SUBJECT: NuScale Power, LLC Responses to NRC Request for Additional Information No. 024 (RAI-10185 R1) on the NuScale Standard Design Approval Application

REFERENCE: NRC Letter to NuScale, "Request for Additional Information No. 024 (RAI-10185 R1)," dated May 10, 2024

Response to Request for Additional Information Docket: 052000050

NRC Question No.: 19.2-1

Figure 7.1-1j: Reactor Trip and Reactor Tripped Interlock RT-1

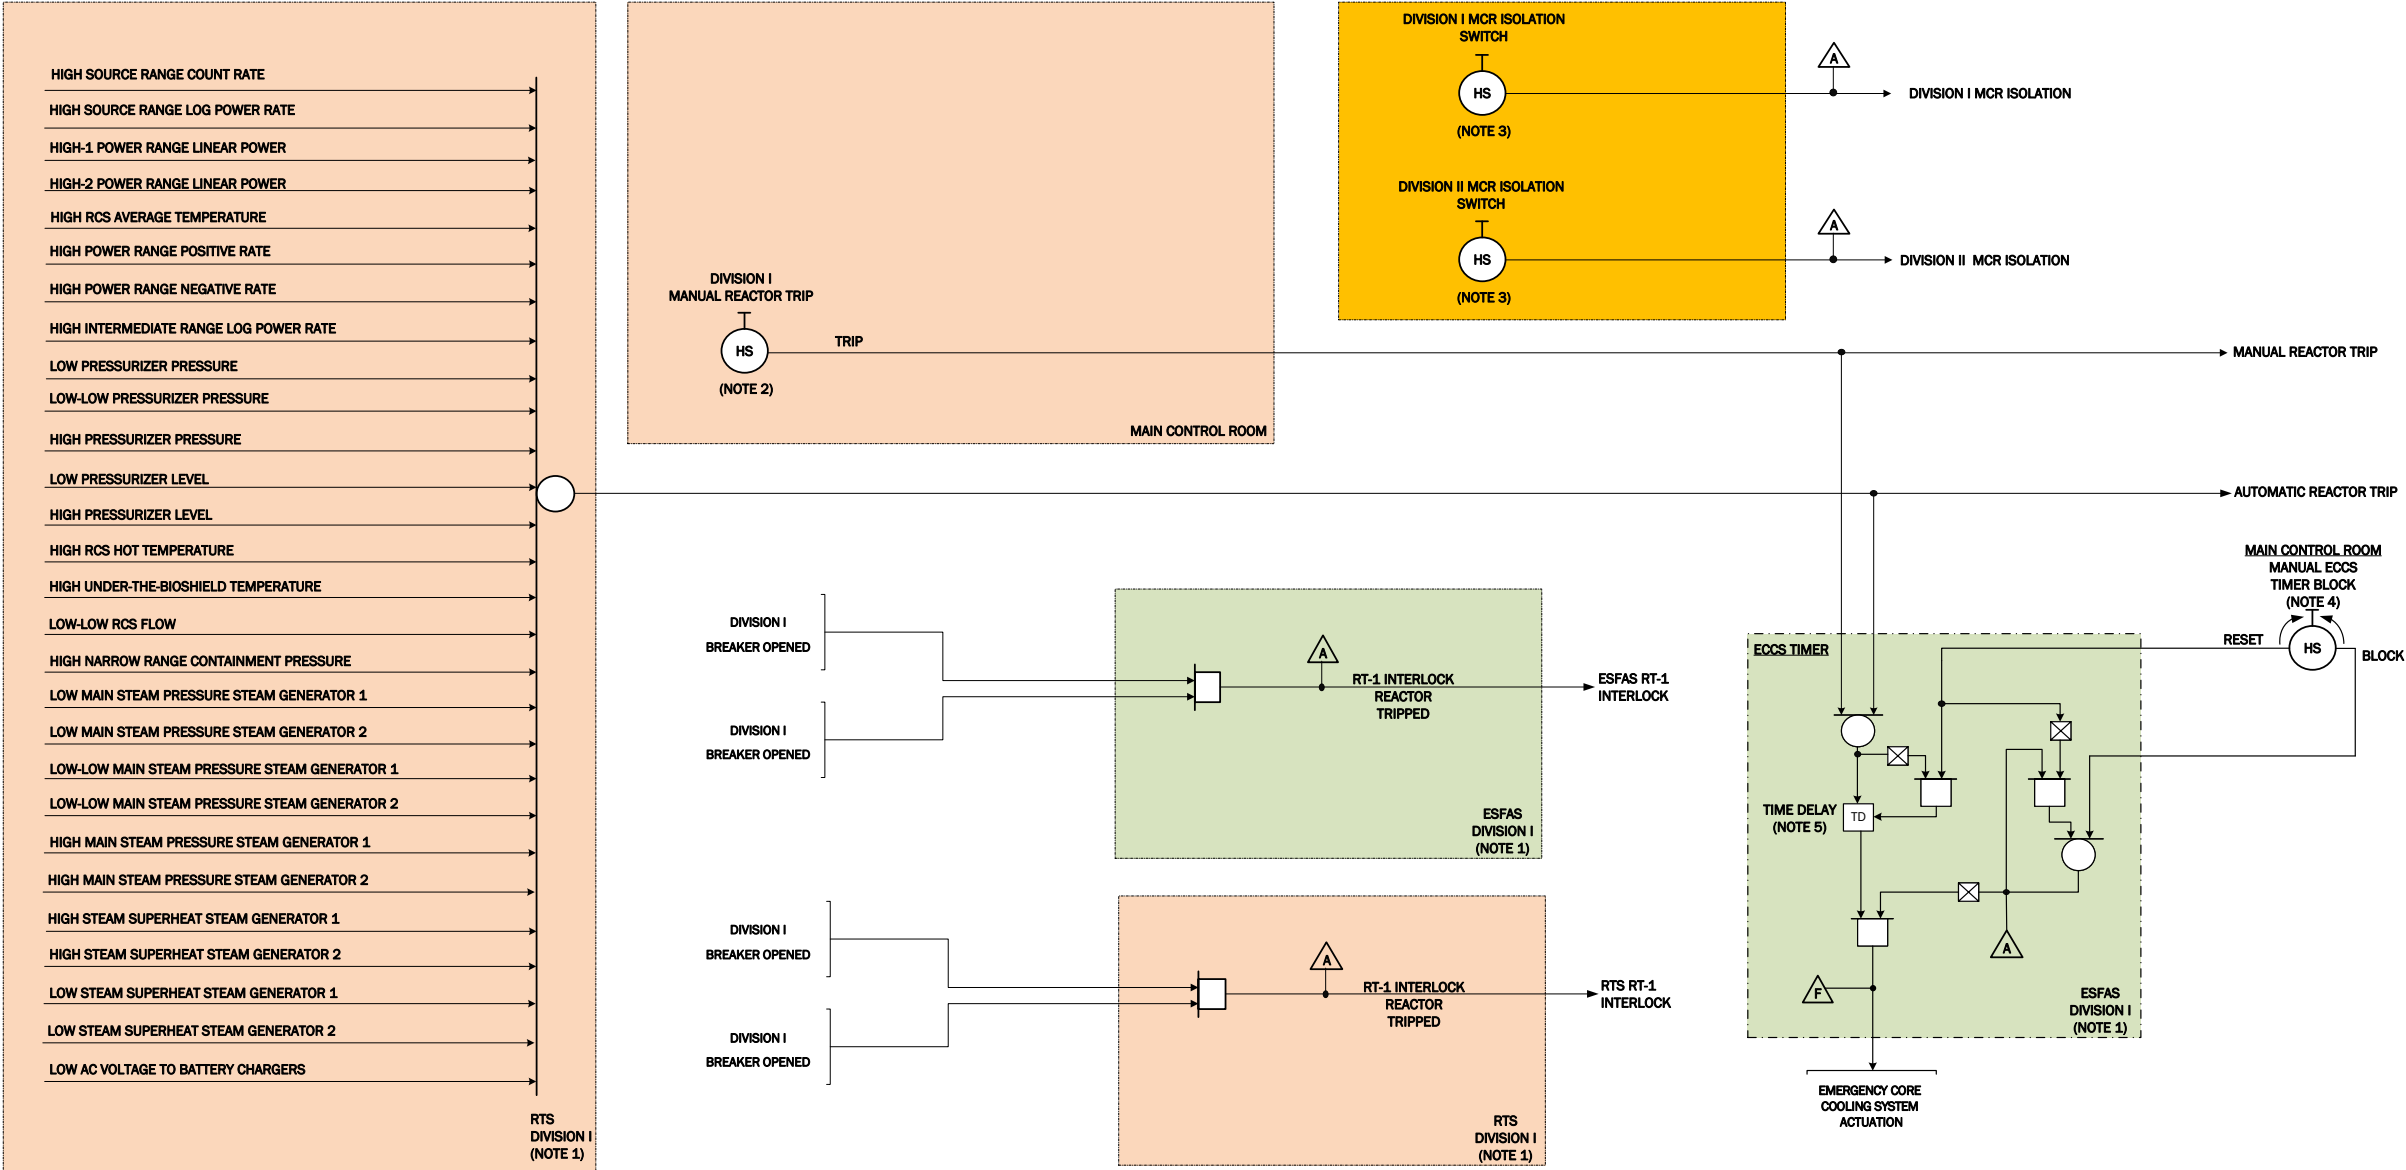
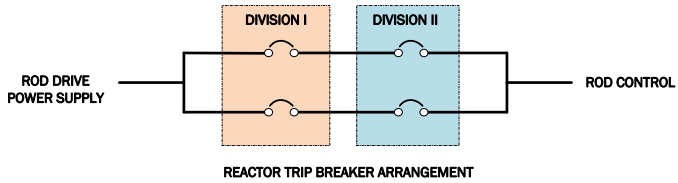
3. NuScale added information about the RCS hydrogen concentration criterion to bypass the 8-hour ECCS timer to FSAR Section 6.3, Emergency Core Cooling System, in response to Audit Issue A-6.3-10. The FSAR pages with this added information are attached to this Request for Additional Information response.

NOTE 4: ECCS ACTUATION 8HRS AFTER REACTOR TRIP MAY BE MANUALLY BLOCKED BY OPERATORS IF SUBCRITICALITY AT COLD CONDITIONS IS CONFIRMED AND IF IT IS CONFIRMED THAT THE RPV CONTAINS SUFFICIENT HYDROGEN TO MAINTAIN A CRITICAL HYDROGEN CONCENTRATION IN THE RCS THROUGHOUT DHRS COOLDOWN.
